ERRATA SHEET

WRIR 86-4358 PLATE 1

HYDROGEOLOGY OF STRATIFIED-DRIFT AQUIFERS AND WATER QUALITY IN THE NASHUA REGIONAL PLANNING COMMISSION AREA SOUTH-CENTRAL NEW HAMPSHIRE

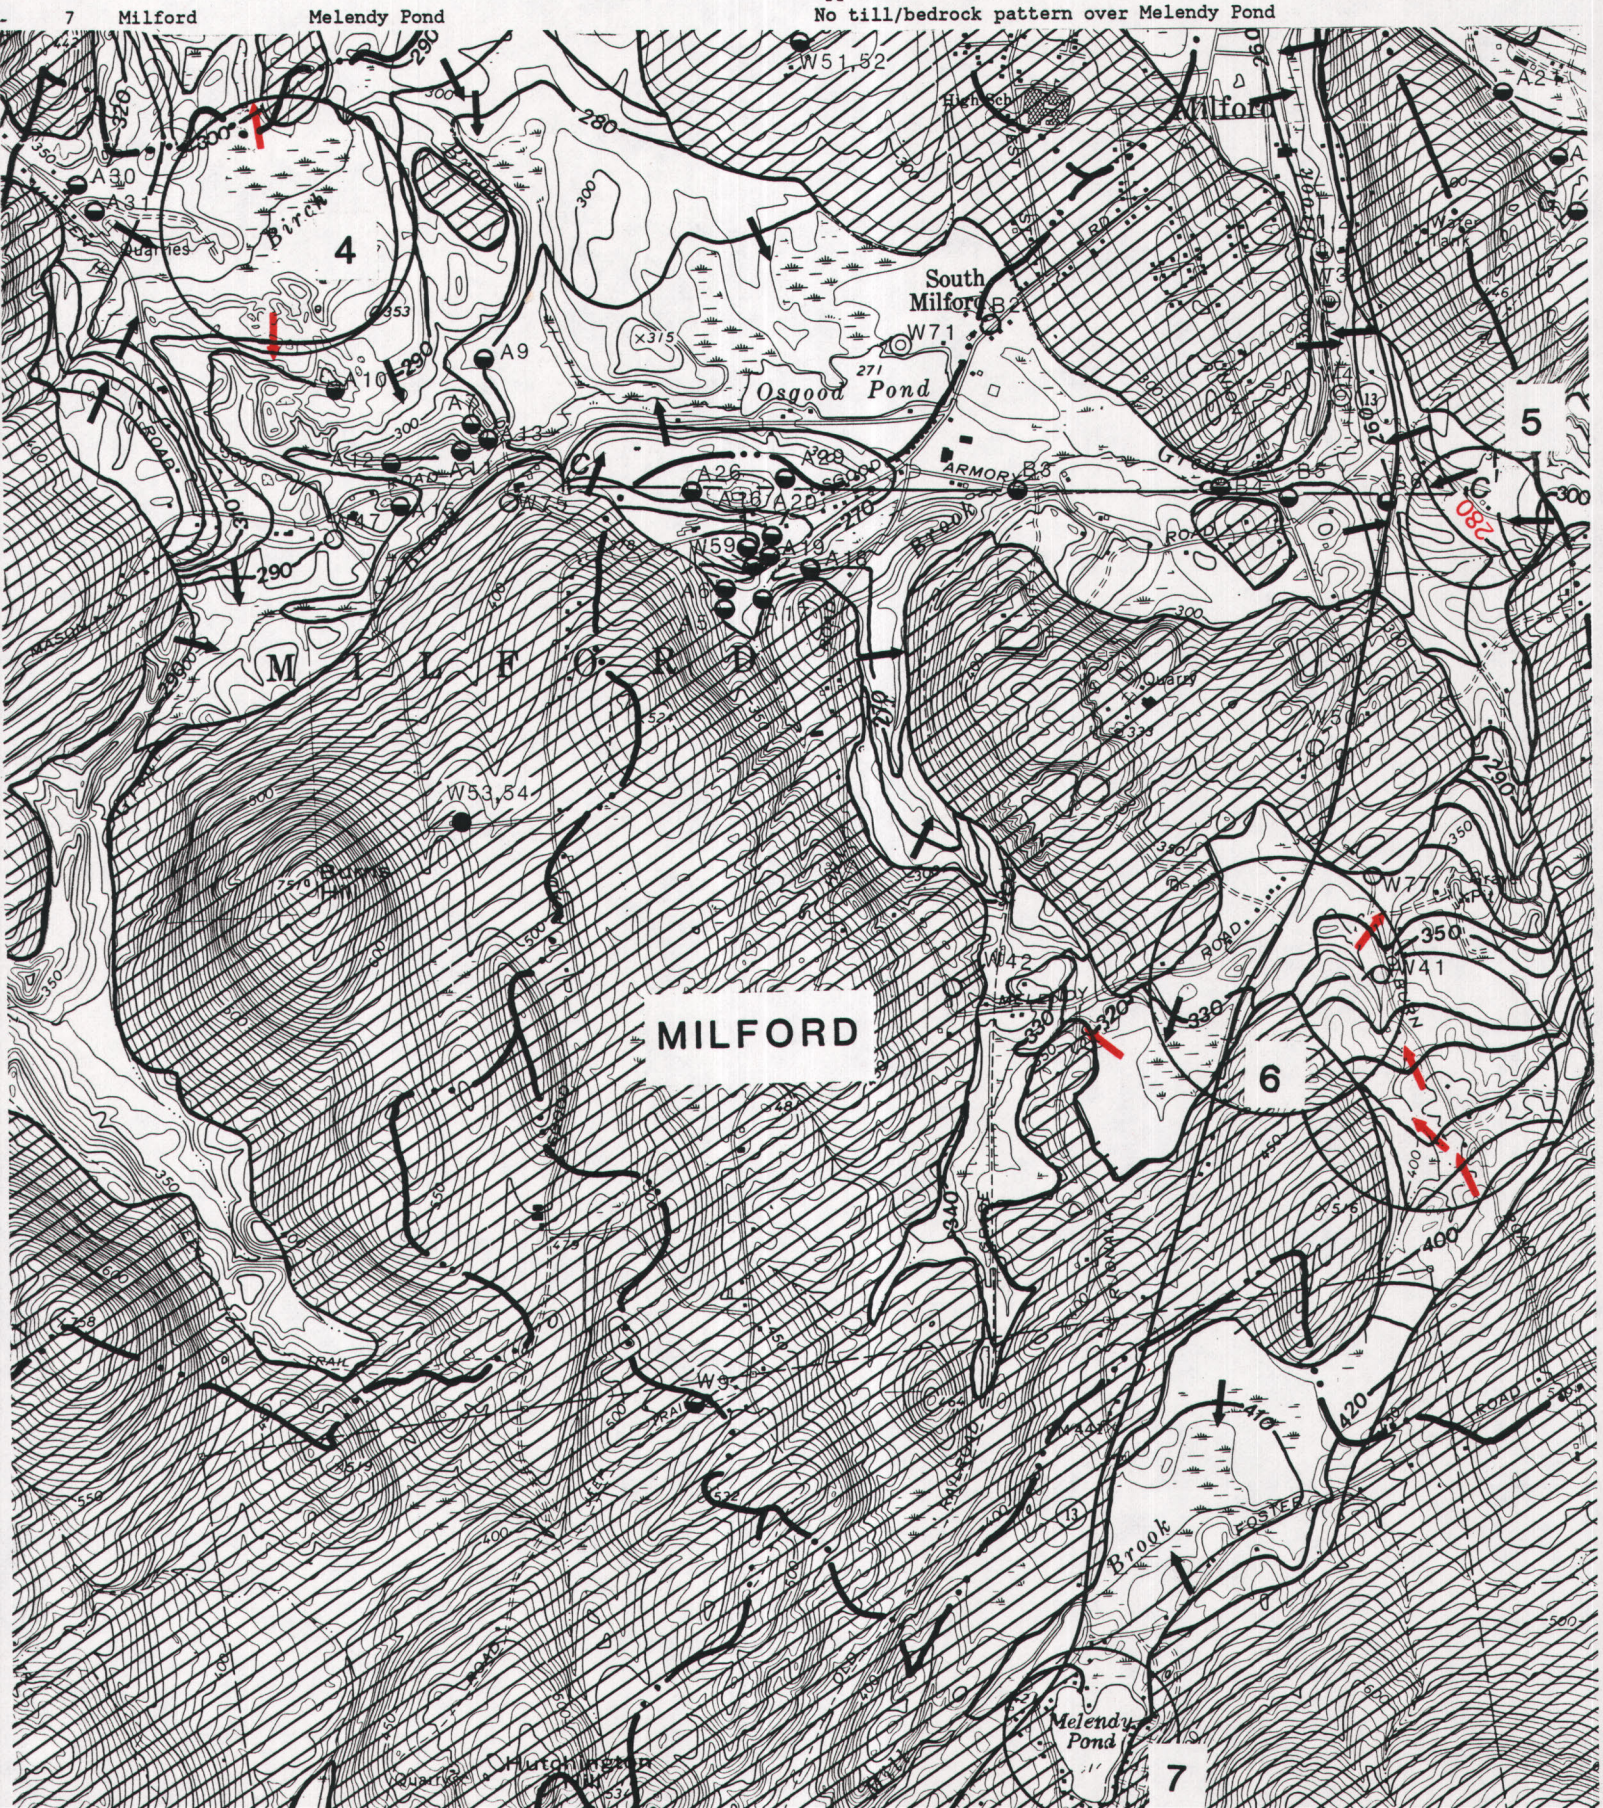
ERROR	TOWN	NEAREST LANDMARK	CORRECTION
4	Milford	Birch Brook area	Flow arrows on water-table contour 300, opposite direction
5	Milford	State Route 13 south of Milford	Water-table contour 250 should be 280
6	Milford	State Route 13/Colburn Road area	Flow arrows on water-table contours 330, 340, 370, 380, 390, opposite direction
7	Milford	Melendy Pond	No till/bedrock pattern over Melendy Pond
